Re: OUT/2019/0022  
RMM/2022/0633 Dwellings (284) Tamworth/Fivefield Road

I object to this application because

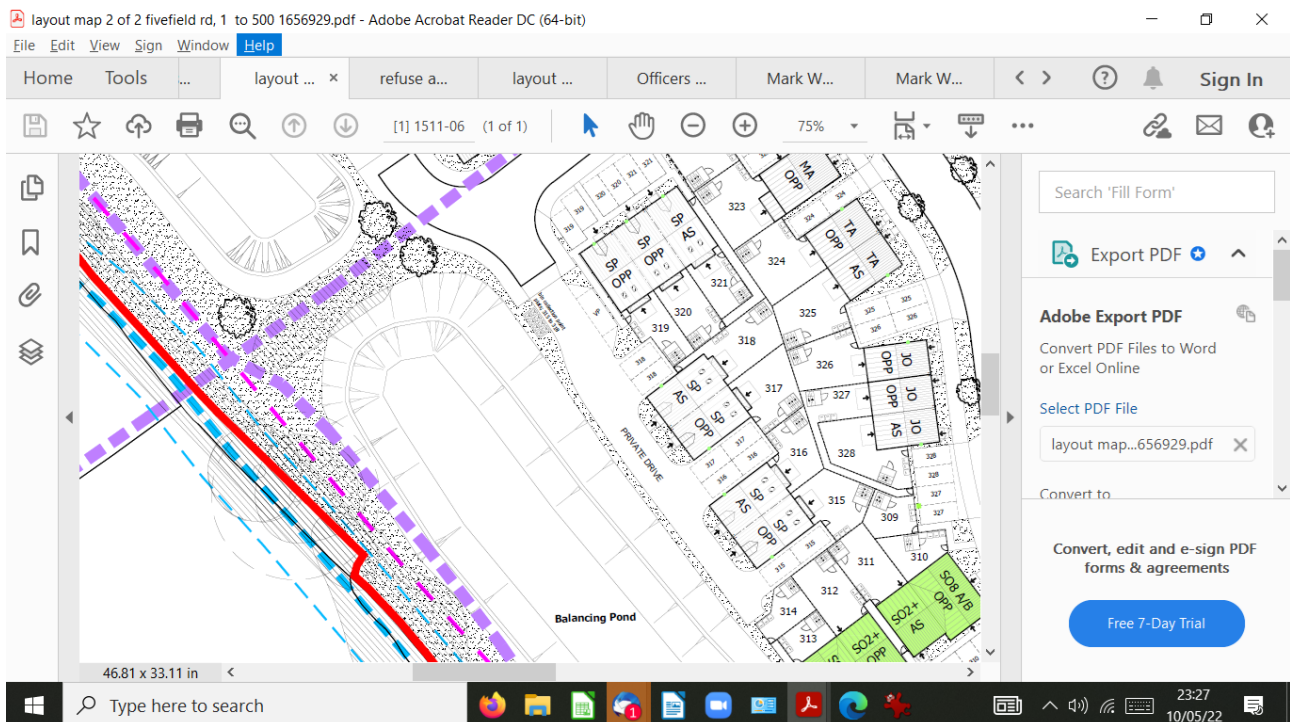
Focus: plot 273. the access private drive is 39m long (around the bend) and there is no turning place

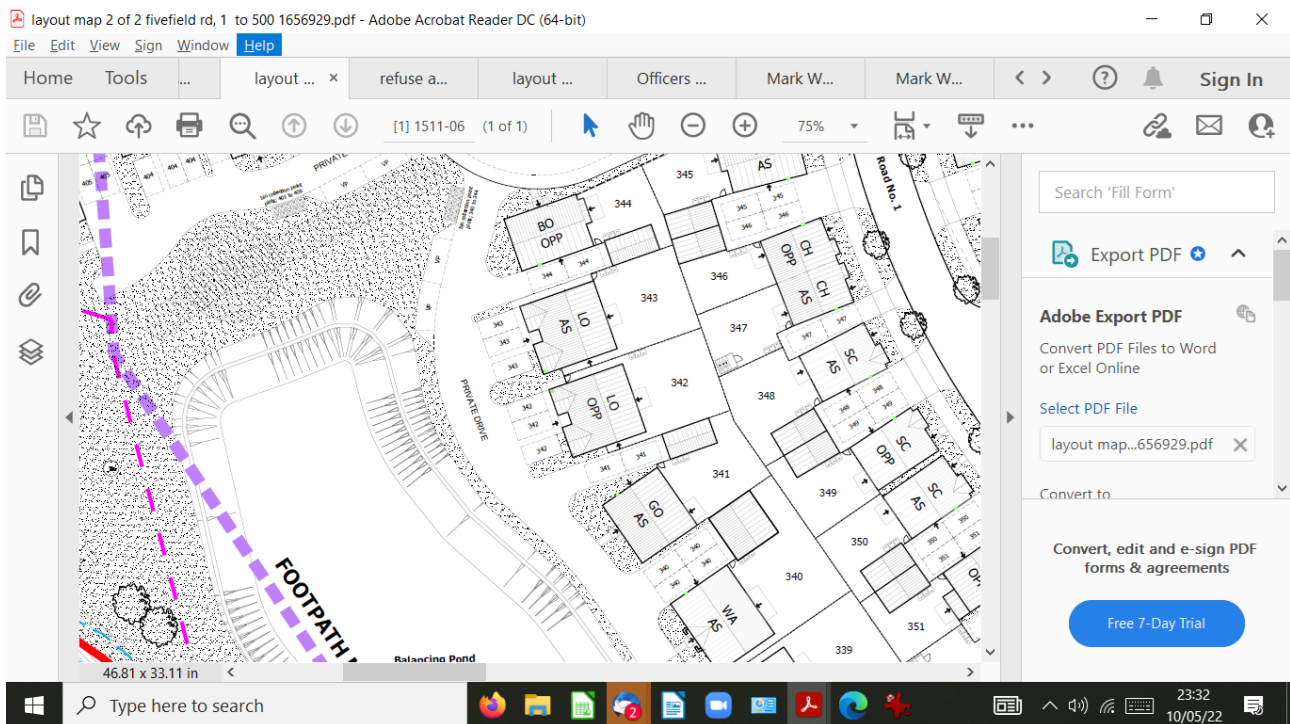
Focus house 314. private drive is 51m long and has no turning point of the required width [16.8m] the max turning space is 5.6m if cars are in the bays.

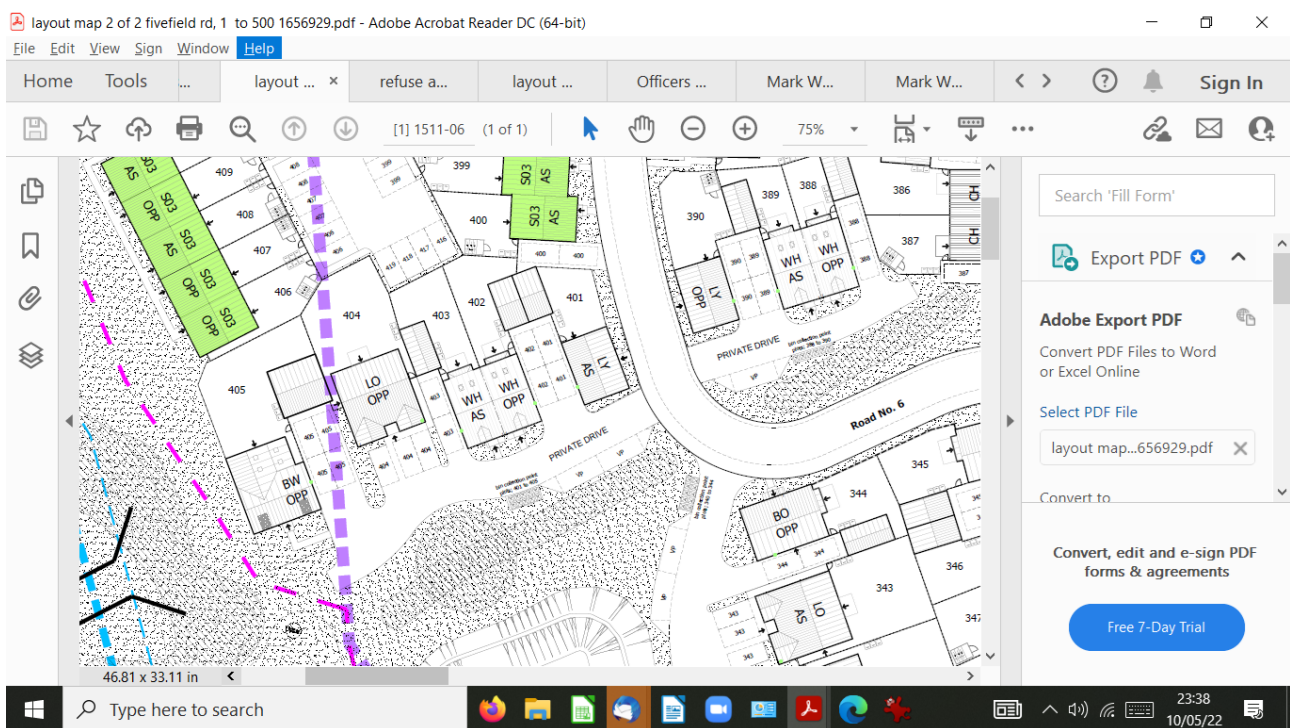
Focus: plot 344 and nearby. The private drive is 108 m long. The max turning space, if the car bays are occupied is 8.4 m (16.8 is min the regs)

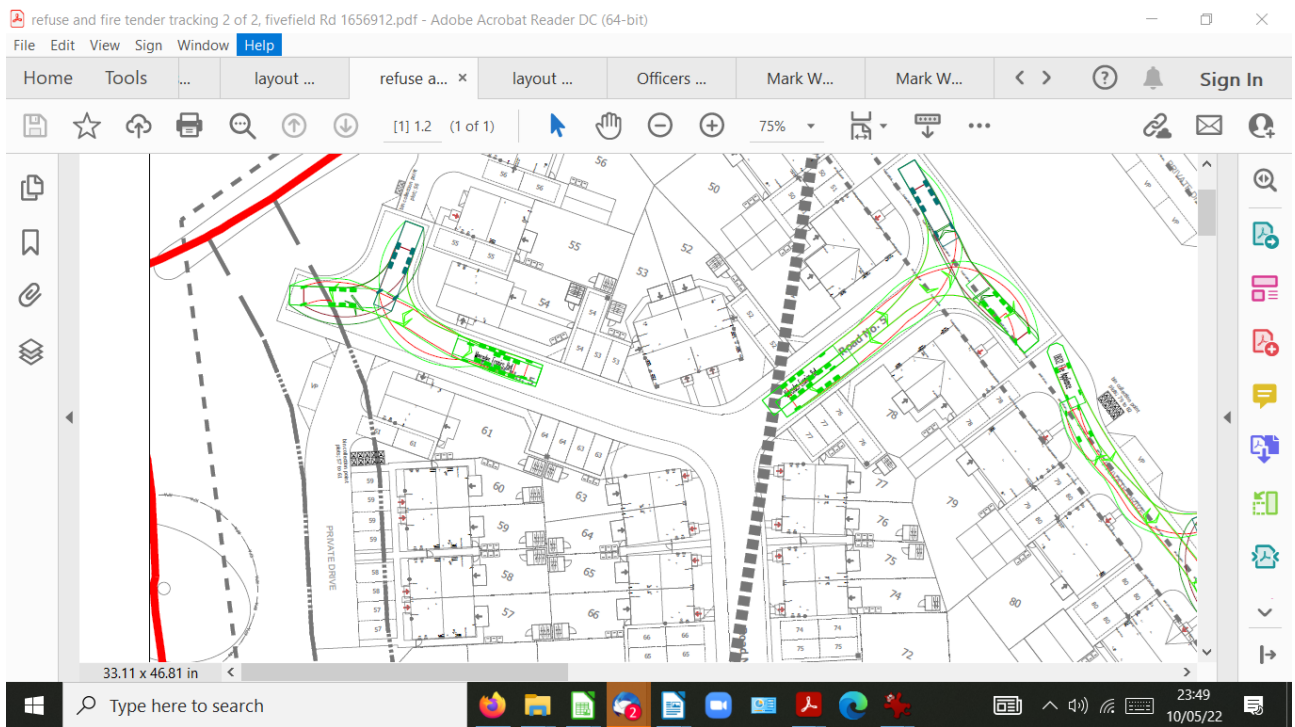
Focus: plot 405 and nearby. The private drive is 47m long and has no turning space – the widest turning point is 5.5m

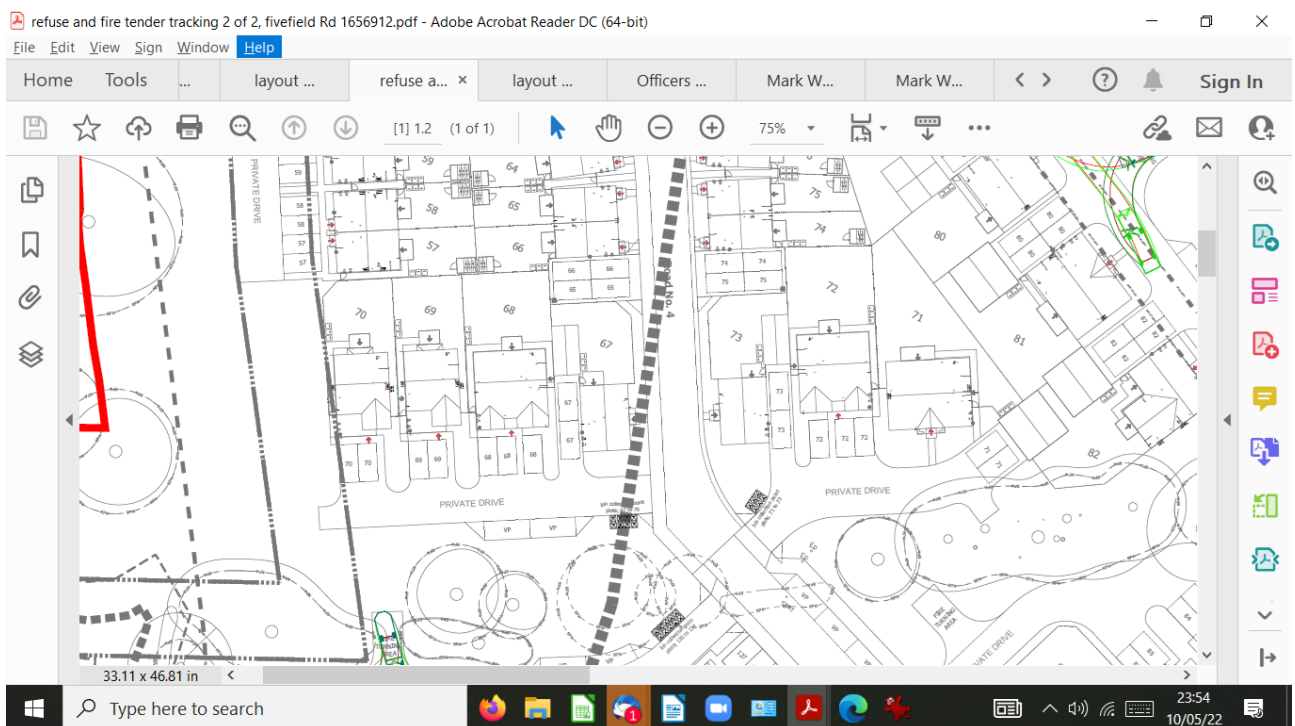
Focus: plot 61 and nearby. The private drive is 38 m long and has no turning point.

plots 67-70. private drive is 42 m long and has no turning point. The best turning width is 5.5m if the car bays are occupied.
